**Technical Service
BULLETIN**

**OCCUPANT CLASSIFICATION
SYSTEM INITIALIZATION
(DTC B1150 & B1650)**

'04 Camry, Highlander & Solara

REVISÉD
EL002-04
ELECTRICAL

Sensitivity Check Procedure

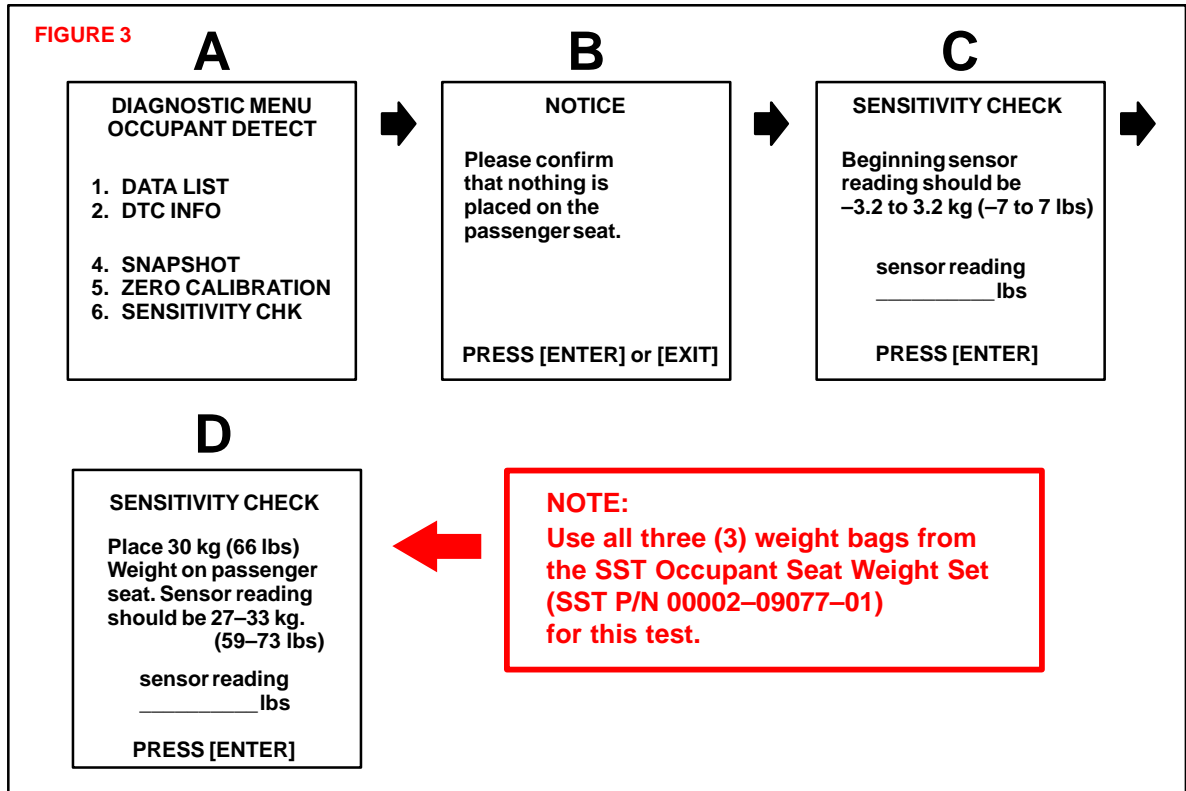
May 11, 2004: Introduction has been clarified, OCS SRS codes identified, new SST "Occupant Seat Weight Set" (P/N 00002-09077-01) added to Required Special Service Tools, "Note" added to Figure 3 on page 4. Previous versions of this TSB should be discarded.

If the Sensitivity results deviate more than 7 lbs. (3.2 kg) from the actual weight on the seat:

1. Remove the test weights from the seat.
2. Loosen and retighten the mounting bolts of the passenger seat taking care not to deform the seat rail.

Torque: 37 N•m (375 kgf•cm, 27 ft•lbf)

3. Repeat the Zero Point Calibration with the seat empty and in the proper position.
4. Re-perform the Sensitivity Check Procedure.

If the Sensitivity results continue to deviate more than 7 lbs. (3.2 kg) from the actual weight on the seat, replace the seat frame adjuster assembly (or seat assembly for Solara).
